UNITED STATES PATENT AND TRADEMARK OFFICE

Office Action Summary

This is the first office action for application number 10/717,788, Waste Container Stabilizer, filed on November 20, 2003.

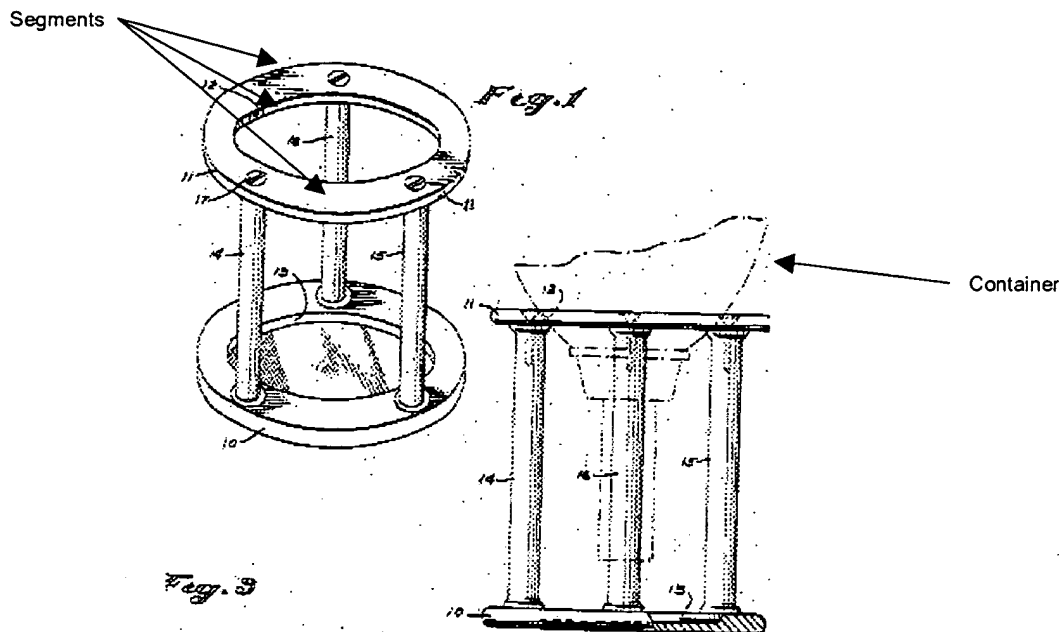
Alexander '081 discloses a stabilizer (above) comprising a support ring (11), and a plurality of legs (14,15,16), wherein the support ring comprises a segmented support ring comprising a plurality of segments (above), wherein a container (above) is sized to fit within the support ring when the stabilizer assembly and the container are supported on a surface, wherein rotation of the legs relative to the support is prevented when the leg is attached to the support ring (inherently, such as when the legs are rotated about an axis different than that of the axis of the leg).

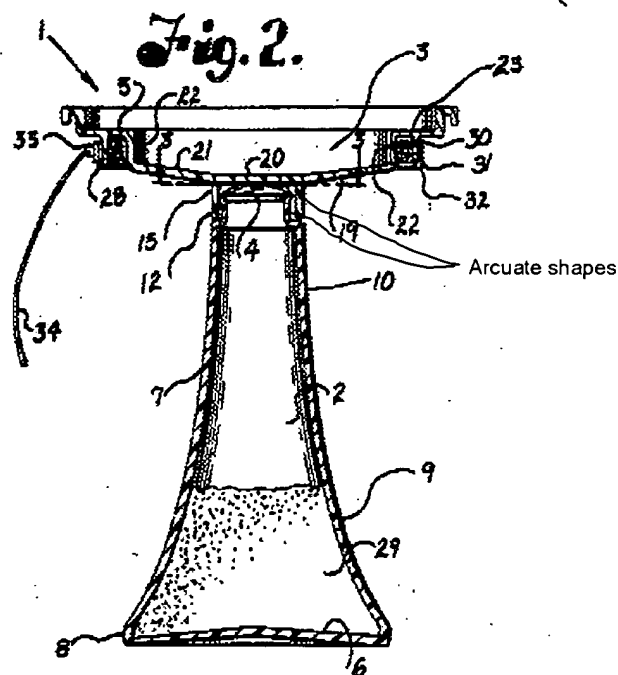
Nevertheless, Jones '659 teaches the concept of filling a leg (2, above) with ballast such as sand or gravel (column 3, line 11) via an opening (near 4) on the top of the leg, such that when the leg is attached to a support ring (3), the opening is covered, wherein each of the legs comprises a top surface comprising an arcuate shape (above, doesn't necessarily appear arcuate in above figure only because it is a sectional view) complementary to the support ring such that the top surface of each of the legs mates with a bottom surface of the support ring when attached thereto (see figure 4).
